DART SERVICE INSTRUCTION

TO AMEND INSTALLATION INSTRUCTIONS D206-558 &
INSTRUCTIONS FOR CONTINUED AIRWORTHINESS ICA-D206-558
REF TCCA STC SH92-17
FAA STC SH1031NE

FIGURE 1 - BRACKET SUBSTITUTION

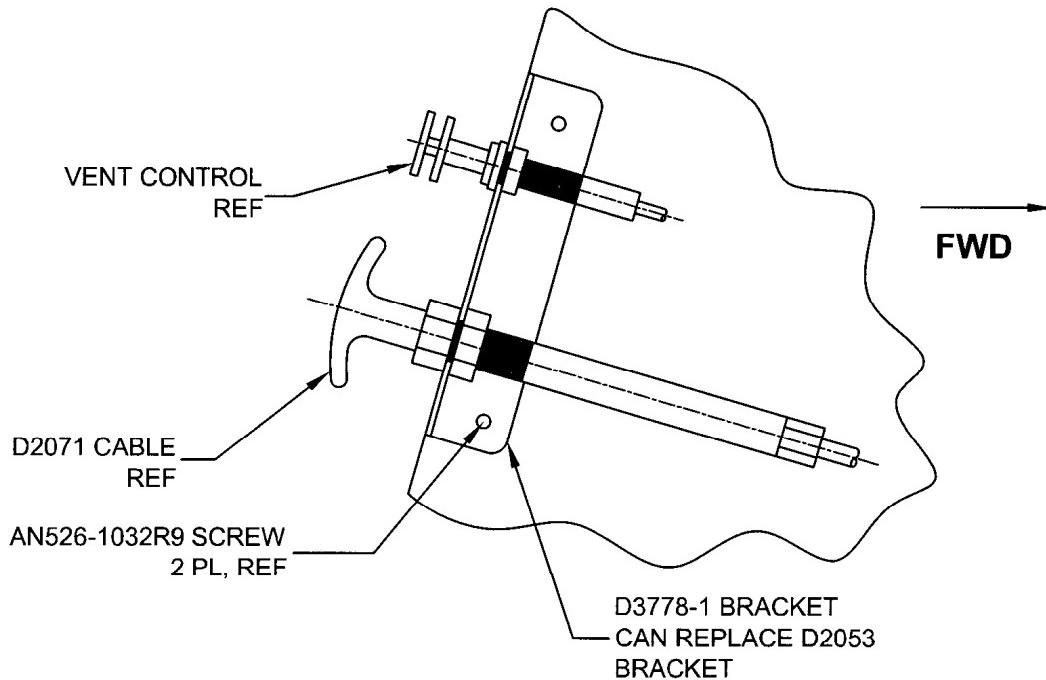
FOR D206-558-041/-043 AT CHG 006 OR LATER, THE D3778-1 BRACKET HAS BEEN ADDED
TO THE KITS TO ALLOW FOR INSTALLATION OF THE VENT CONTROL. THE D2053 BRACKET
CAN BE REPLACED BY THE D3778-1 BRACKET AS DESCRIBED BELOW:

- 1) IF INSTALLED, REMOVE THE EXISTING VENT CONTROL BRACKET AND REMOVE THE VENT CONTROL.
- 2) PICKING UP ON EXISTING ANCHOR NUTS, INSTALL THE D3778-1 BRACKET USING AN526-1032R9 SCREWS.
- 3) INSTALL THE VENT CONTROL IN THE UPPER SLOT. INSTALL THE D2071 CABLE IN THE LOWER SLOT.
